**Town of Kittery
Planning Board Meeting
March 9, 2023**

ITEM 2 – 39 Badgers Island, Sketch Plan Review – Minor Cluster Subdivision

**KITTERY PLANNING BOARD
FINDINGS OF FACT -
for
39 Badgers Island West
Minor Cluster Subdivision Plan**

SHORELAND DEVELOPMENT PLAN

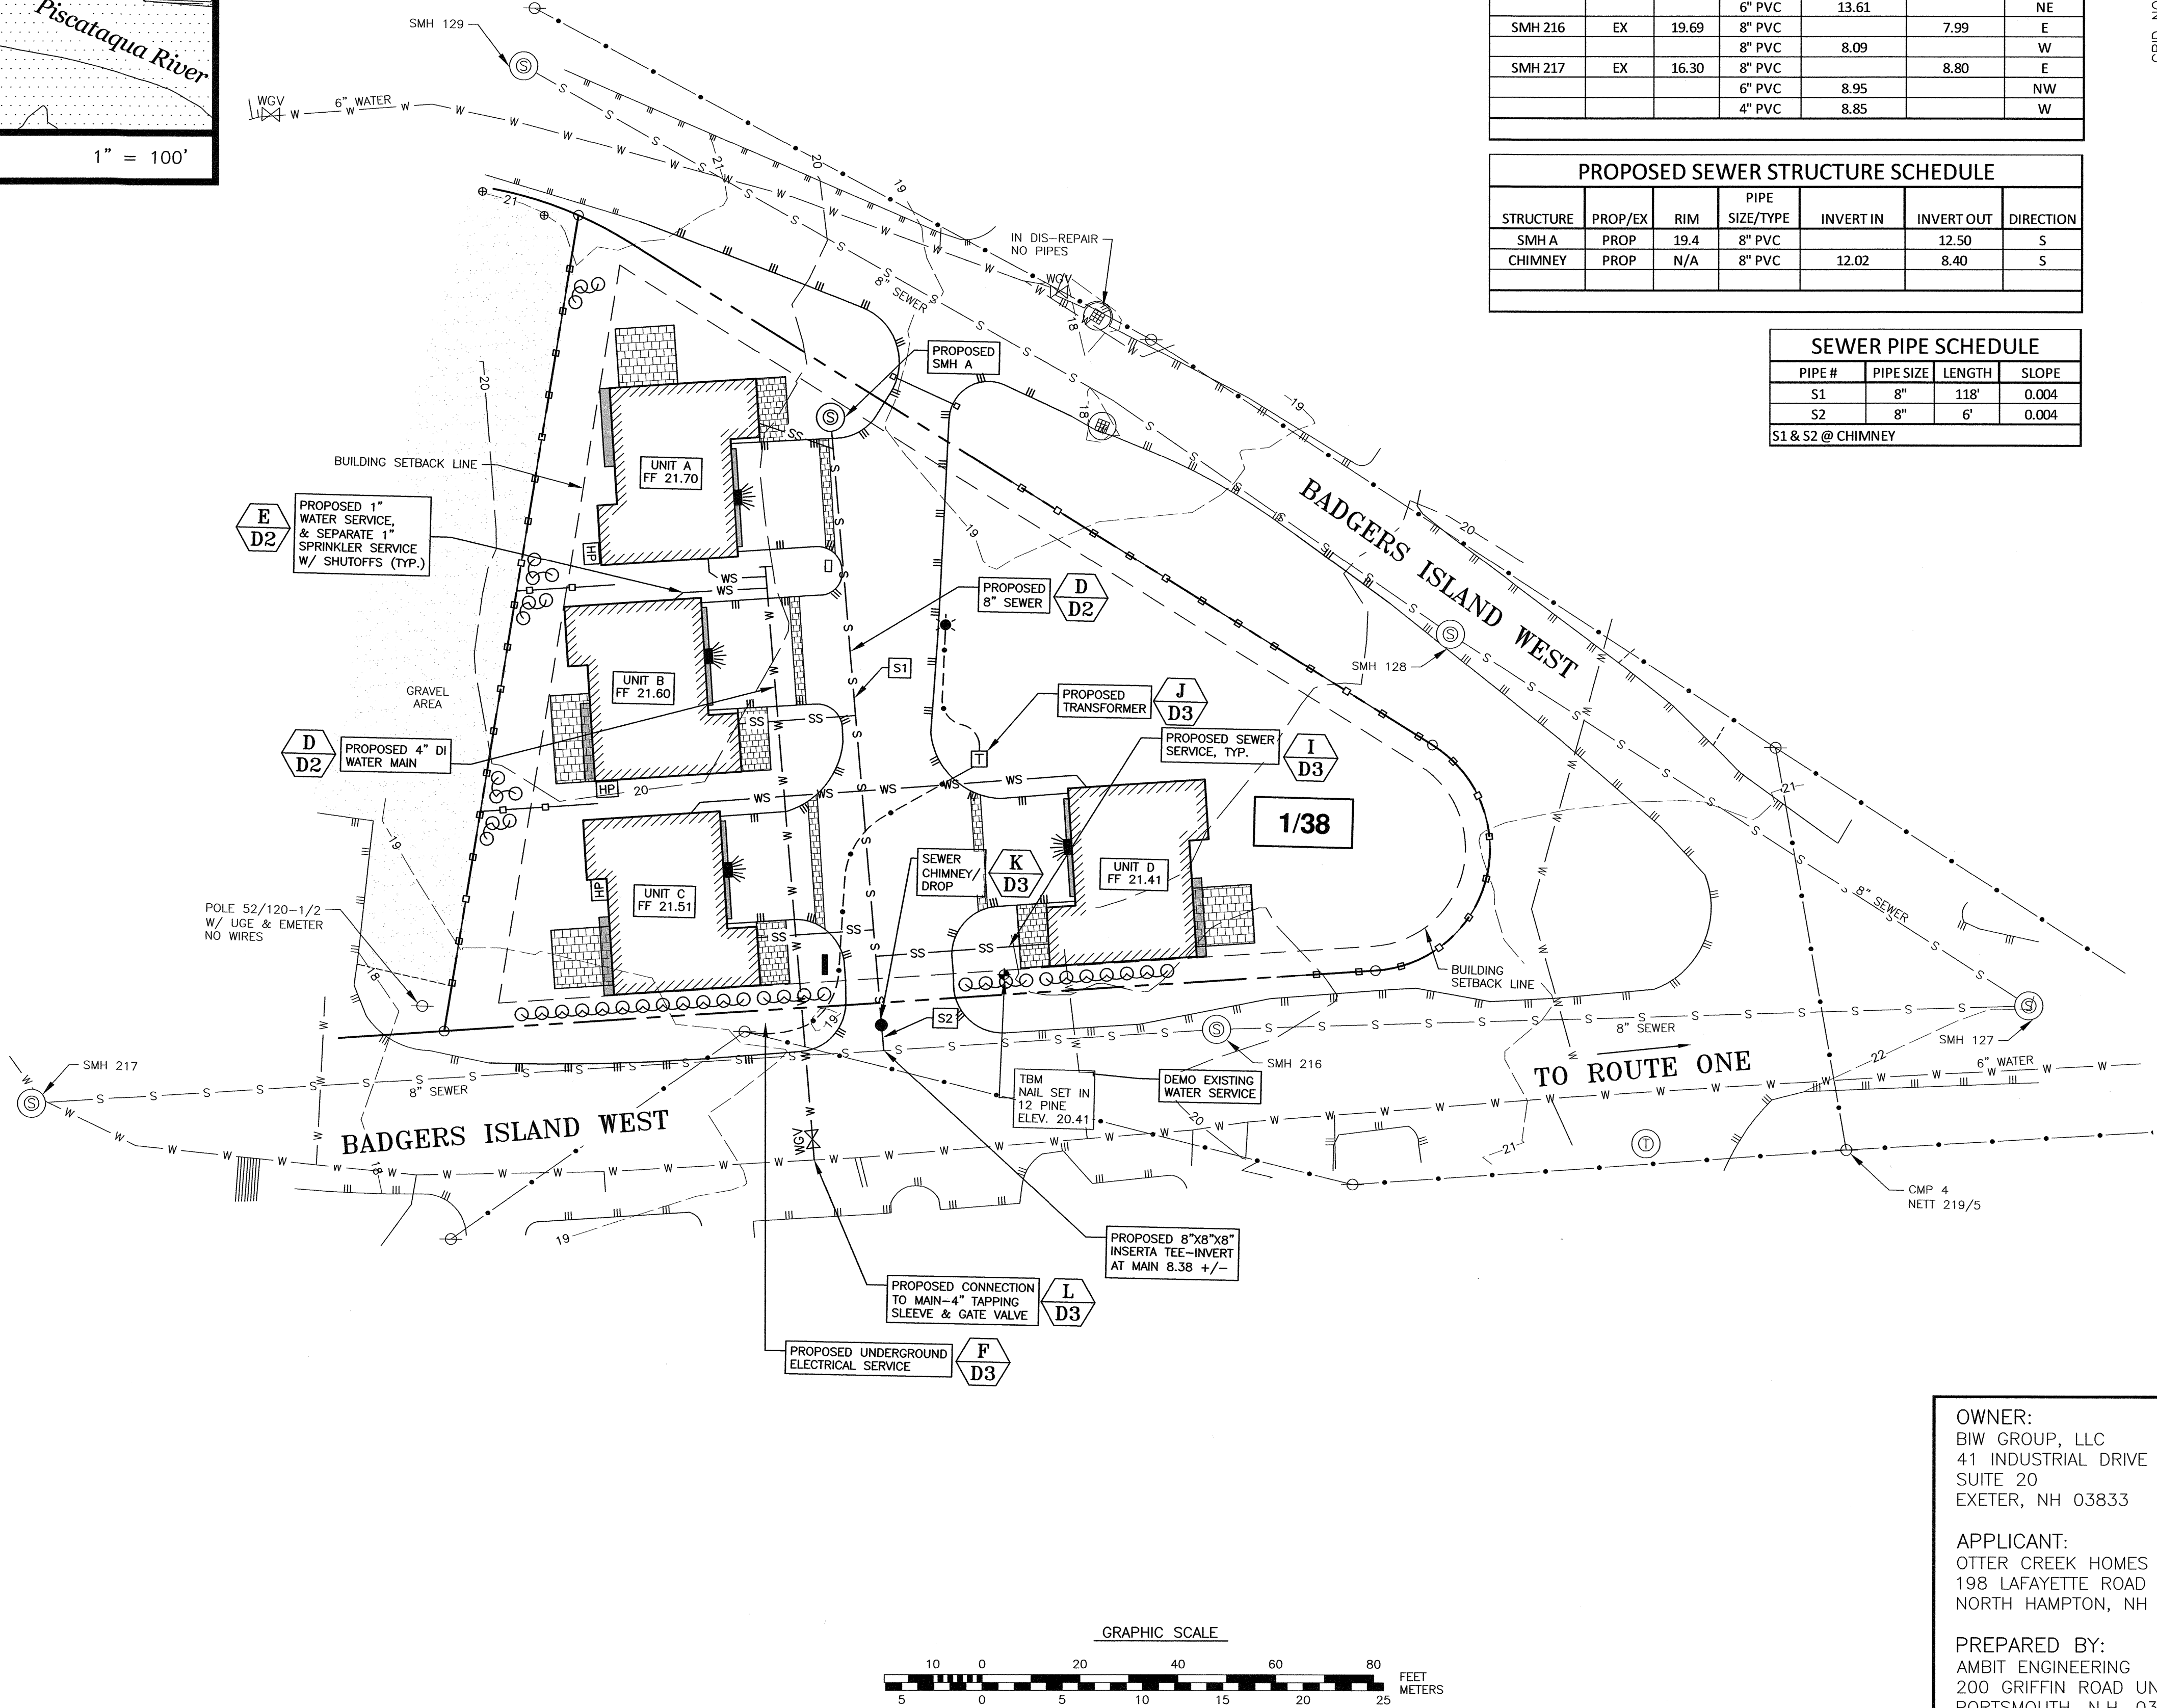
- Shoreland Development Plan C2 – This plan shows the location of the proposed buildings, landscaping, parking, patios, walkways, signage, and driveway entrance. The building siting takes advantage of available views. The plan highlights the existing landscaping (trees) that will be retained. The plan contains the Devegetated Coverage Table. **Revised sign location and added plantings on west property line.**

GRADING
PLAN

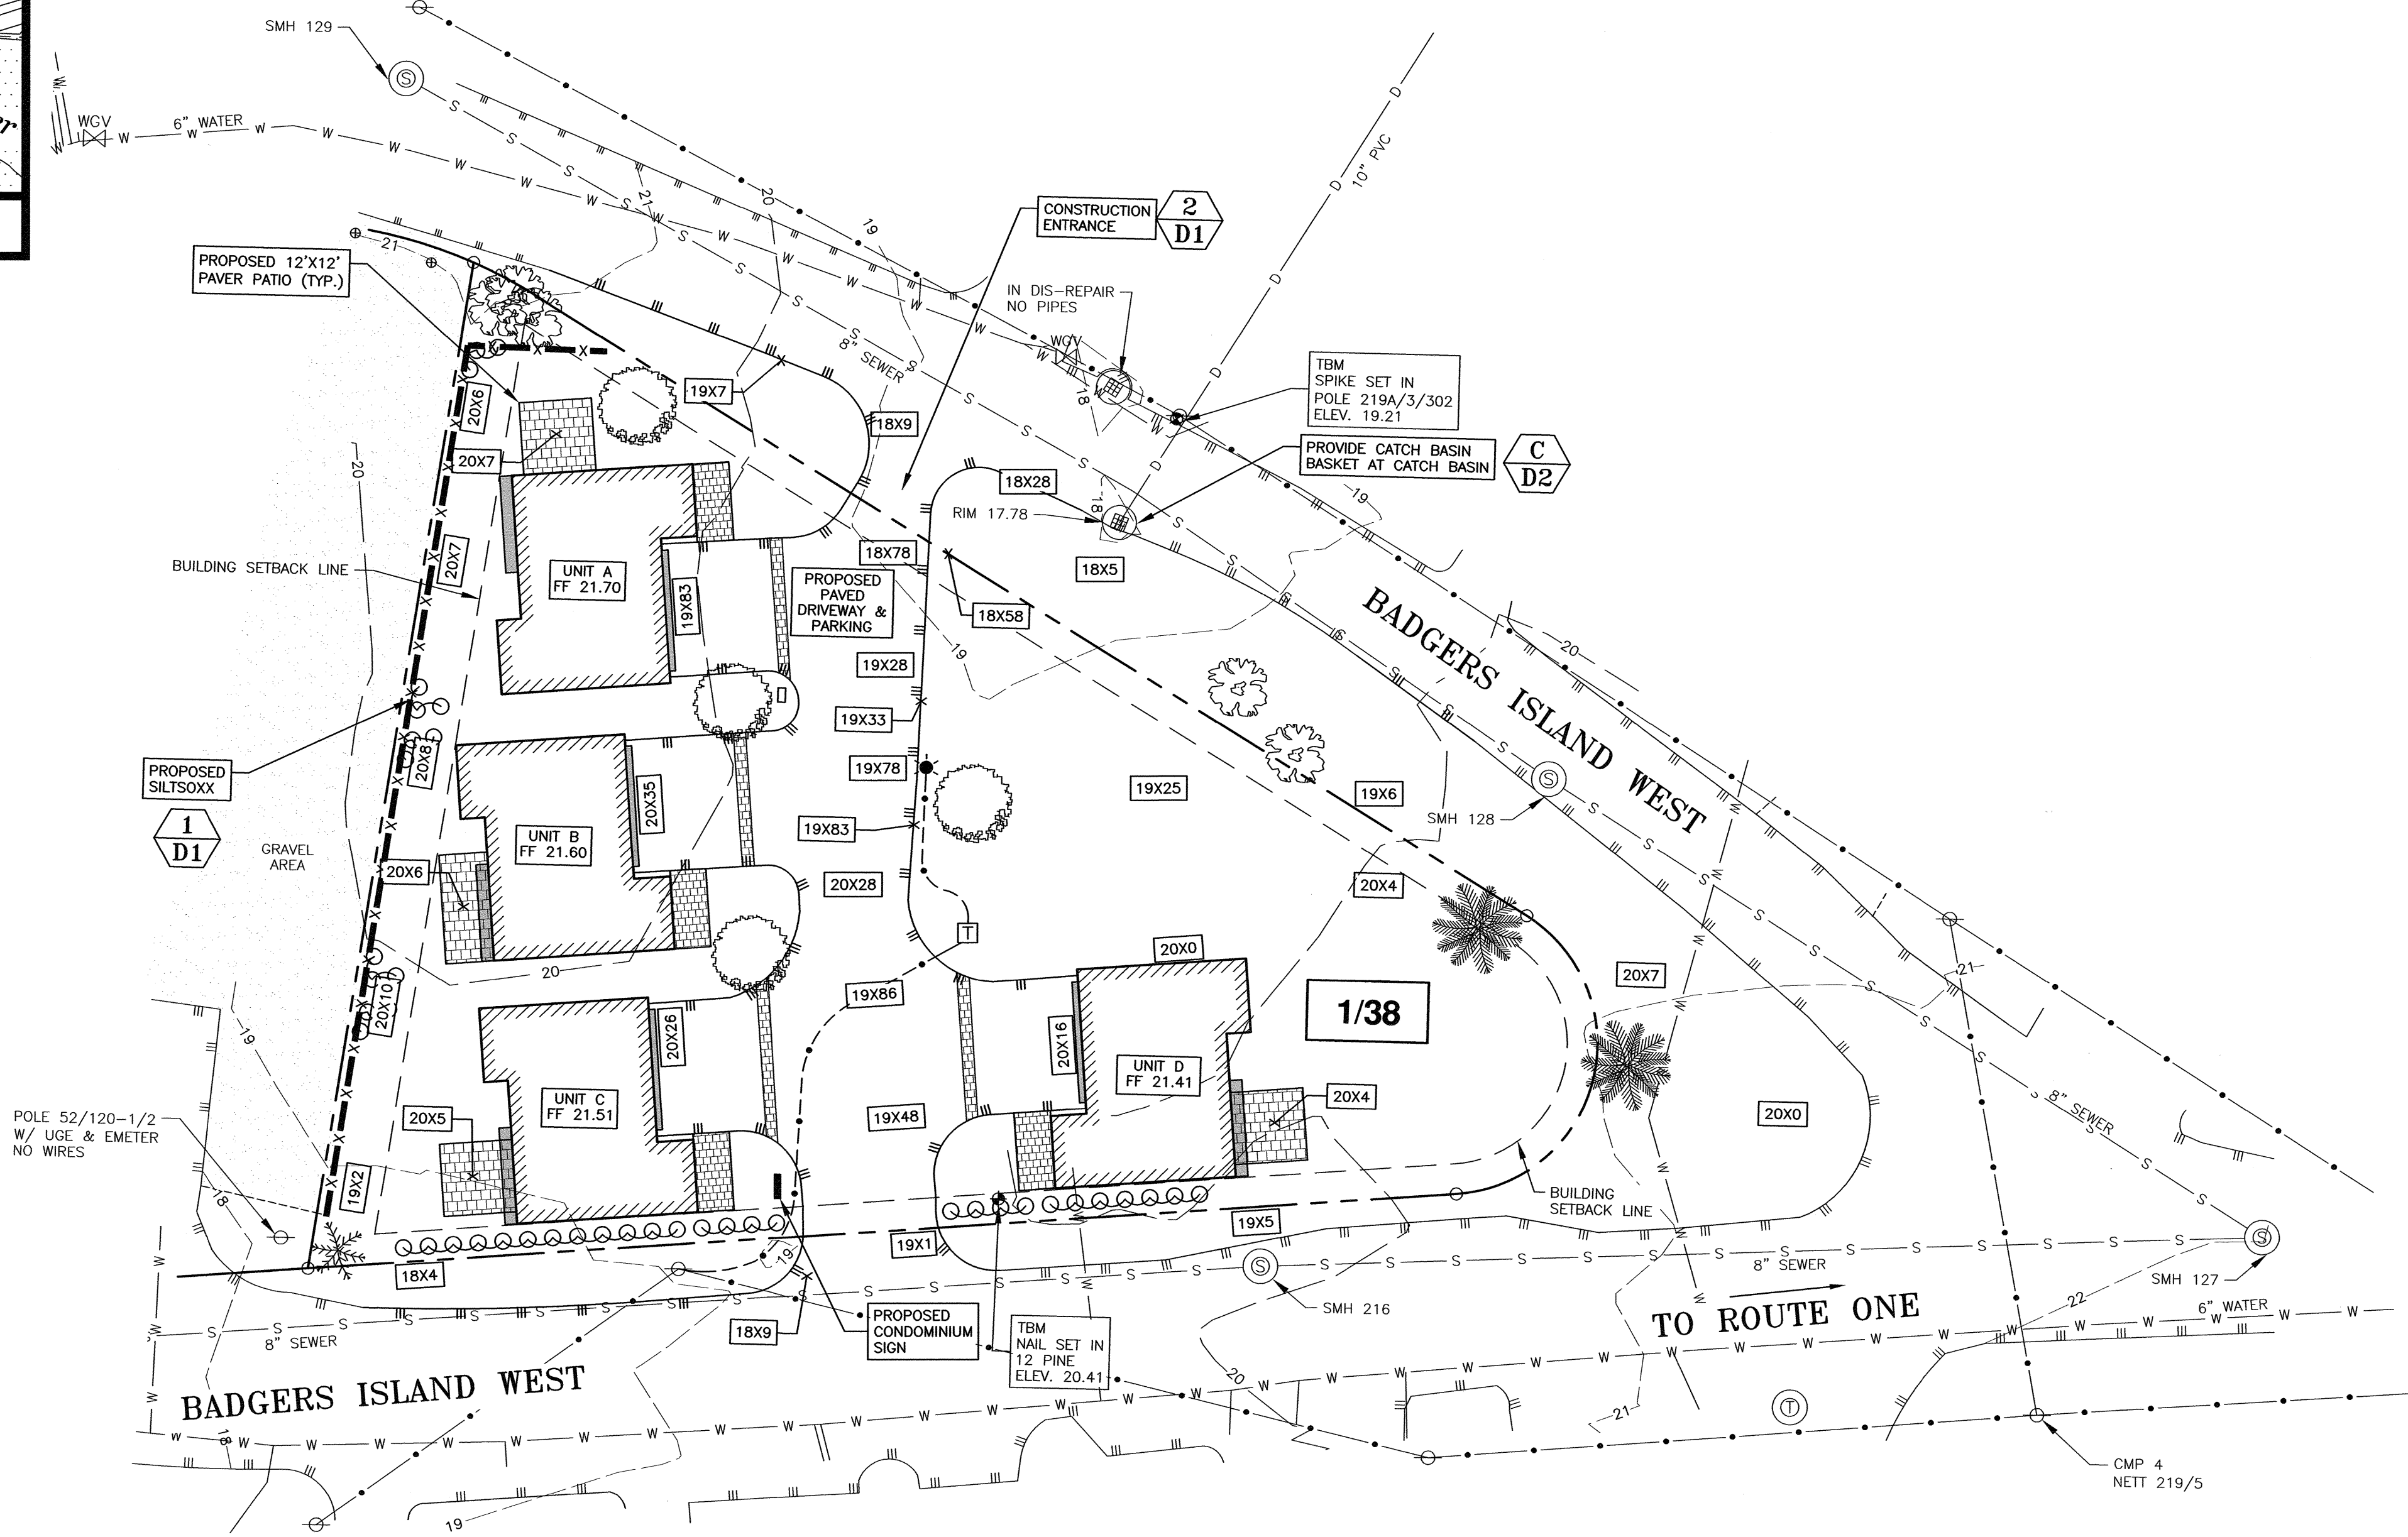
- Grading Plan C4 – This plan shows the proposed site grading. **Revised sign location.**
- Demolition Plan C5 – This plan shows the proposed demolition taking place on the property. **No change.**
